# Tentative Map

Project Name Cadence 47  
(Should match Tentative Map coversheet)

Strive Engineering is in receipt of the City of Henderson's comments on **TMA-2021008514** dated October 7<sup>th</sup>, 2021. Our responses to your comments are below and the revised tentative map has been attached to this letter.

**PLANNING COMMISSION DATE:** November 18, 2021  
**AGENDA ITEM NUMBER:** 2  
**APPLICATION NUMBER:** TMA-2021008514  
**PROJECT APPLICANT:** The LandWell Company, L.P.  
**PROJECT DESCRIPTION:** Cadence 47 Subdivision

TYPICAL LOT/BUILDING LAYOUT  
SCALE: 1" = 20'

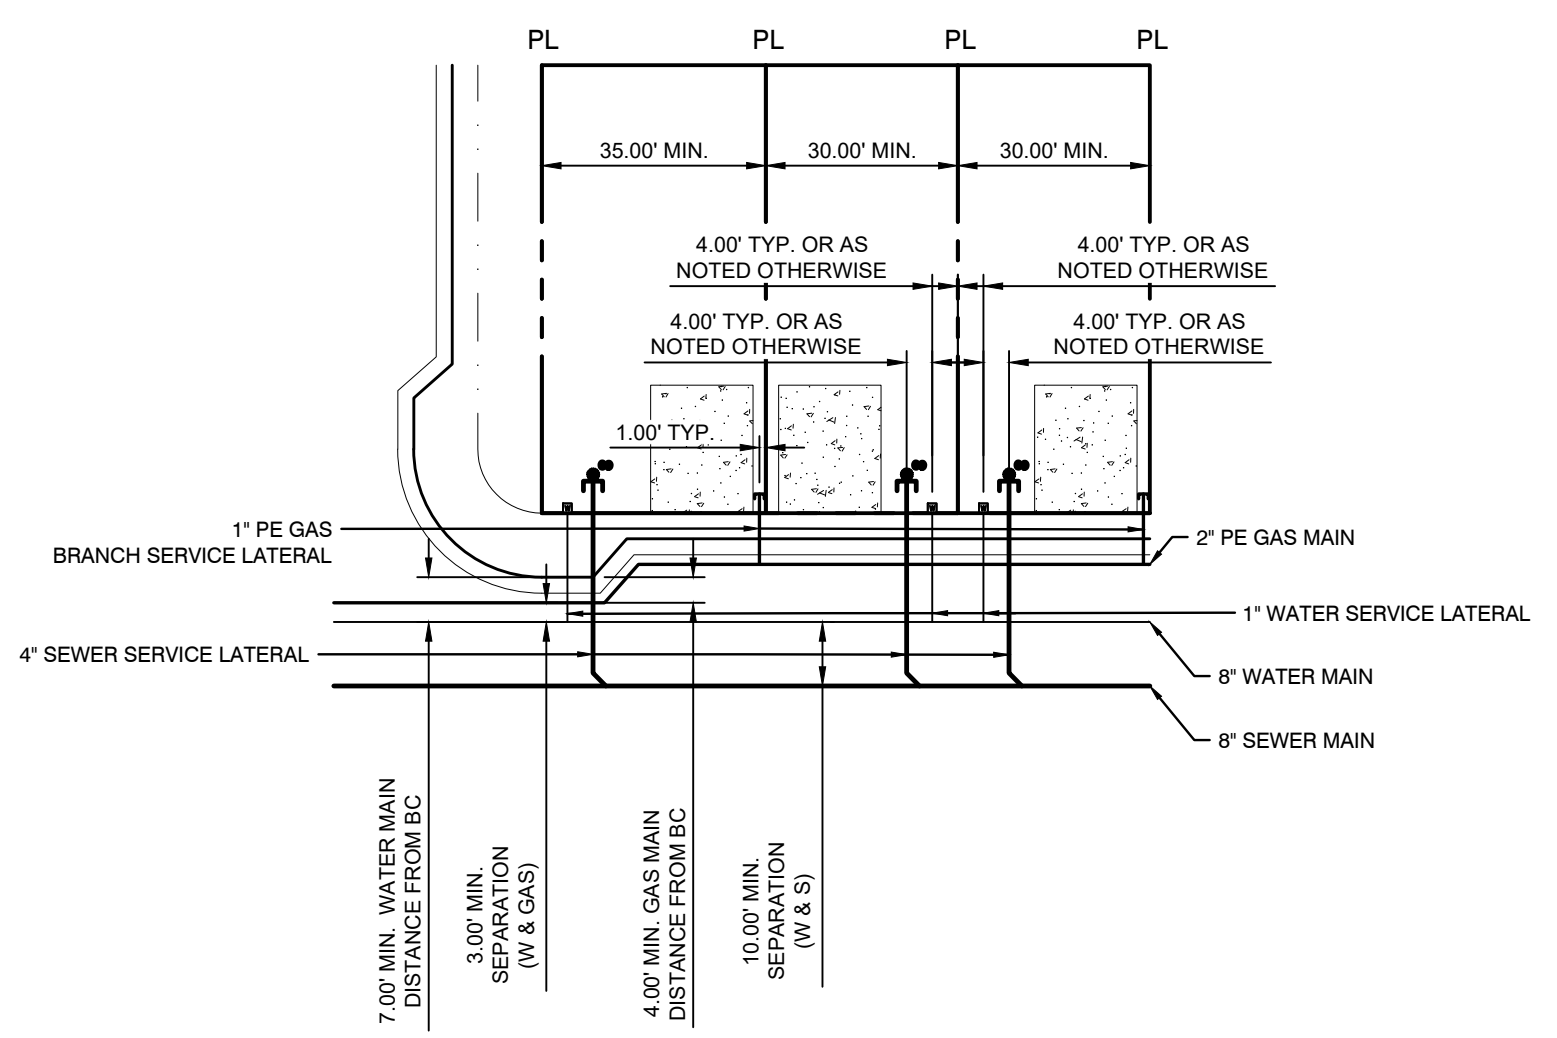
**Comment 5. Provide the typical lot fit on Cover Sheet showing typical building layout on properties with setbacks dimensioned. (CD)**

*Response: Typical Lot Fit is provided on the Cover Sheet.*

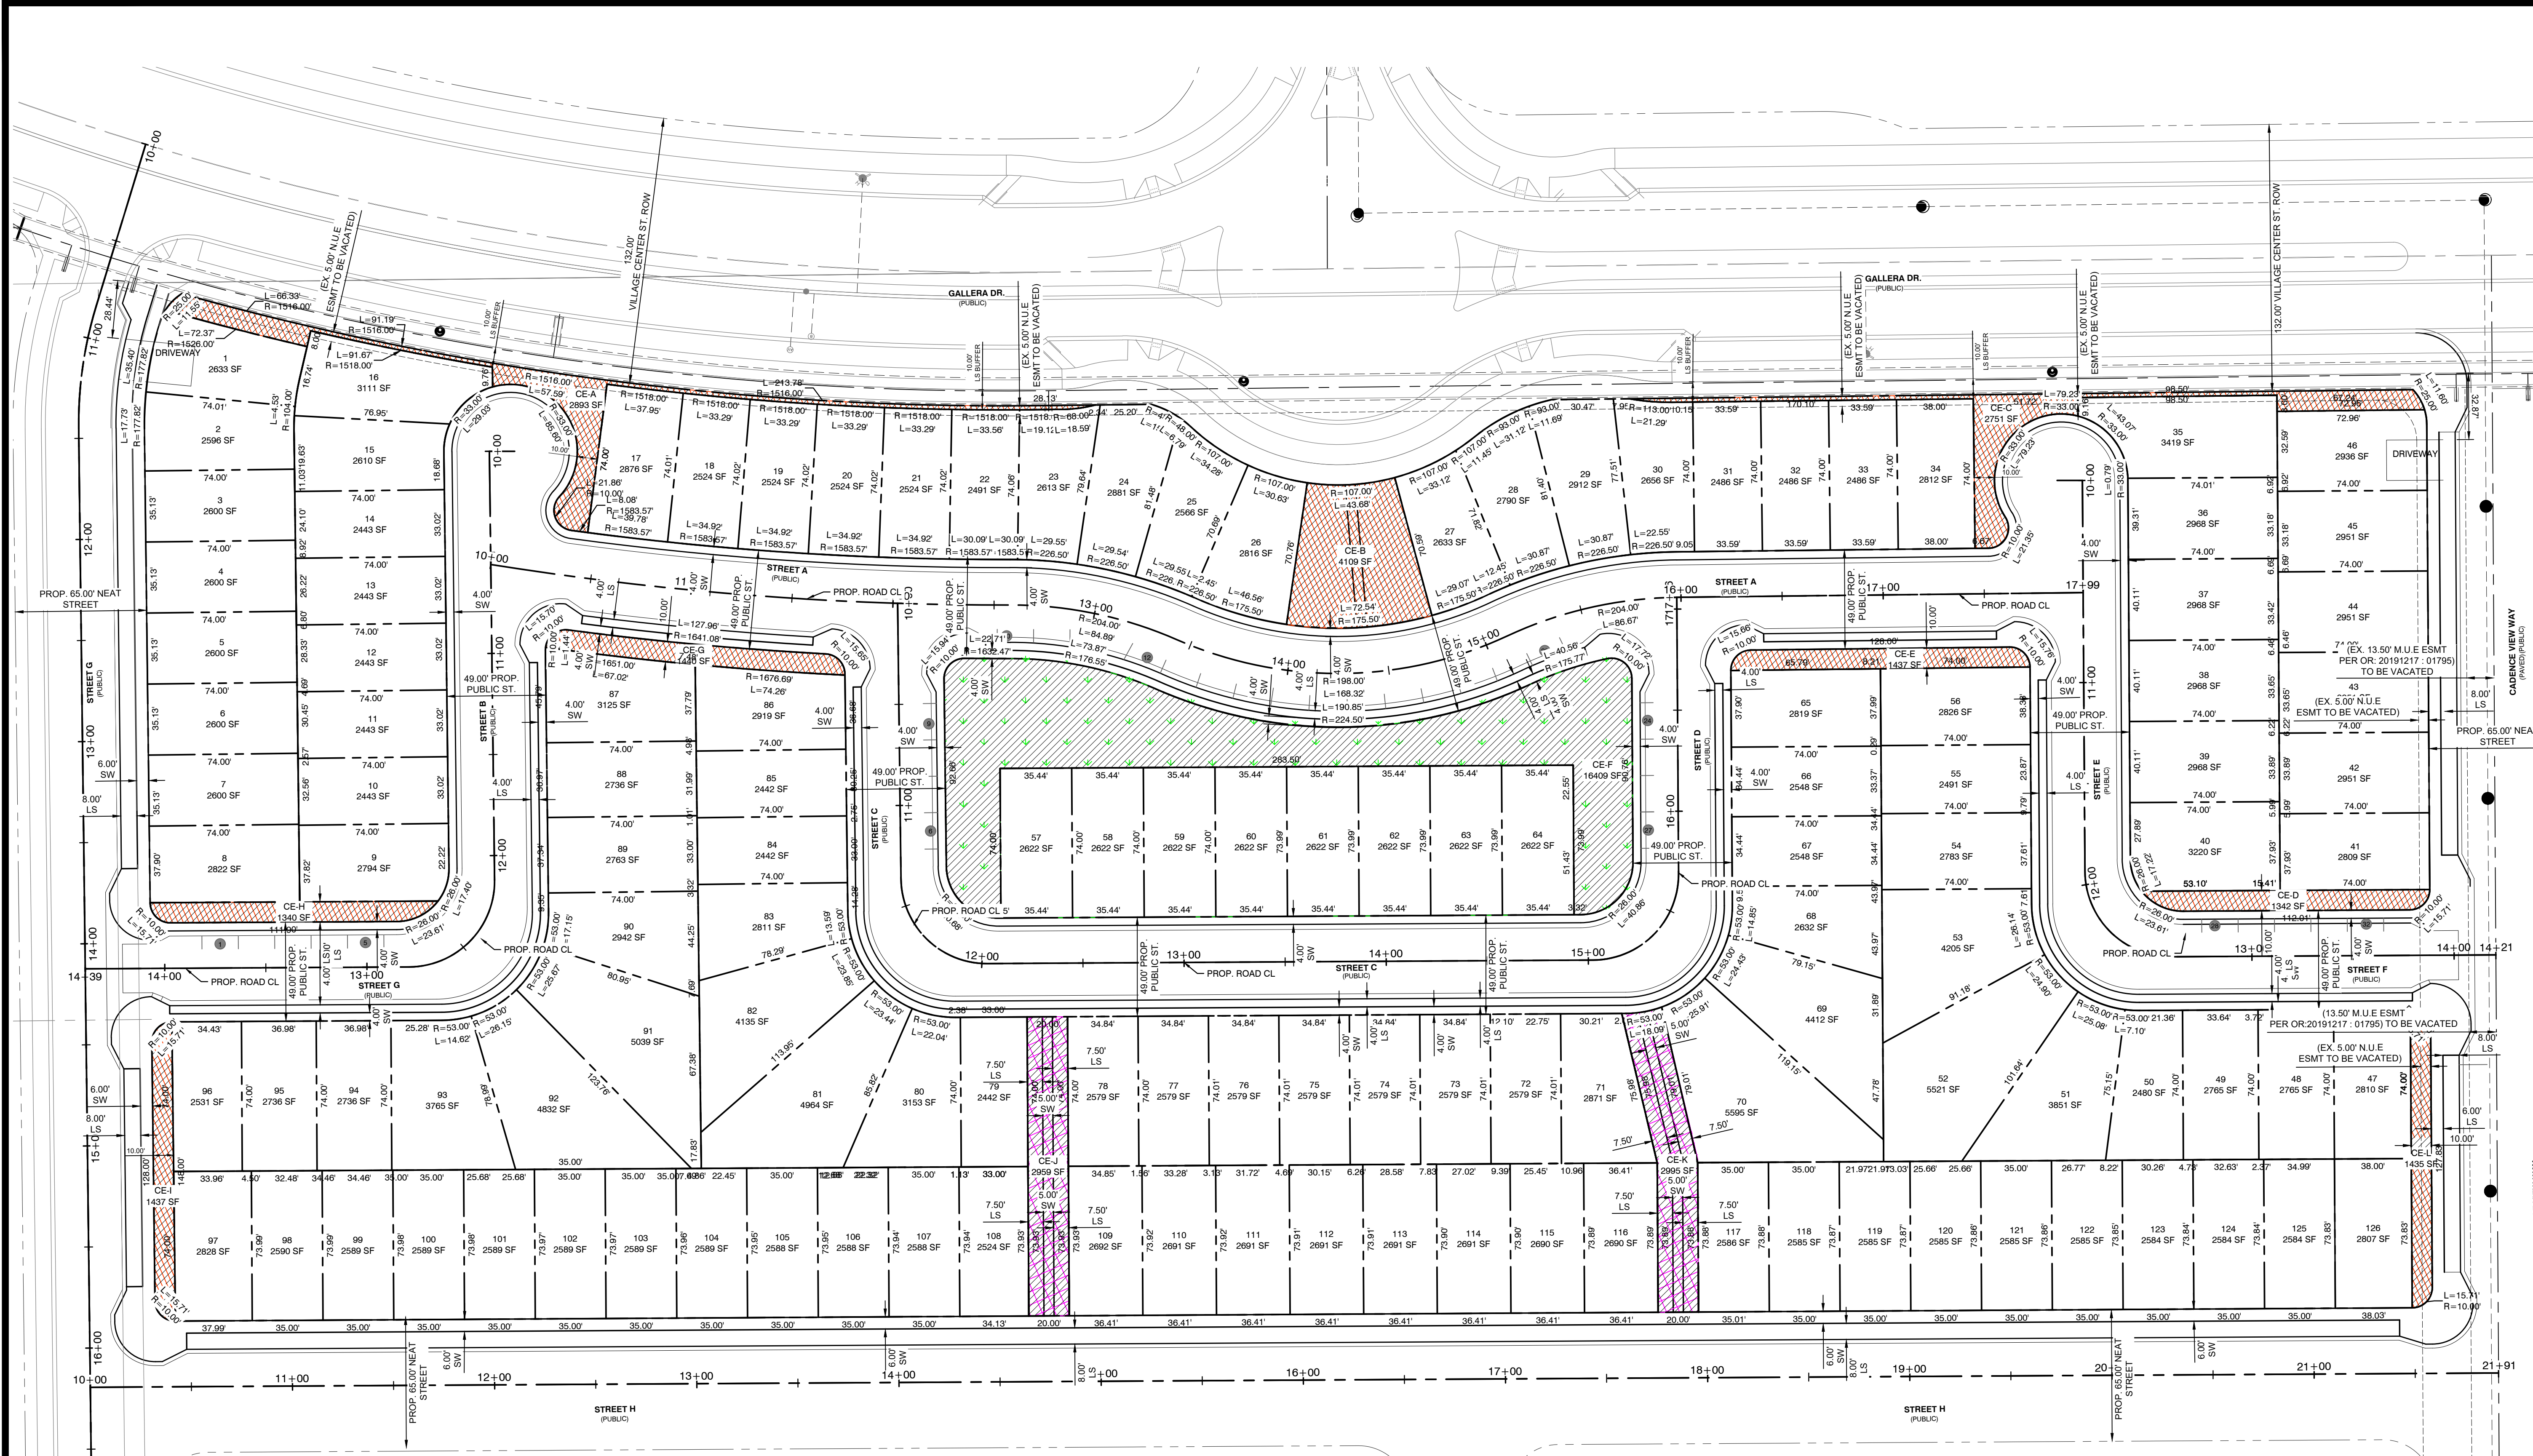
**Comment 10. Please subtotal the Common Element area within the Open Space Summary box on Sheet SP-01. (CD)**

*Response: Total Common Element Area has been added to the Open Space summary table on SP-01.*
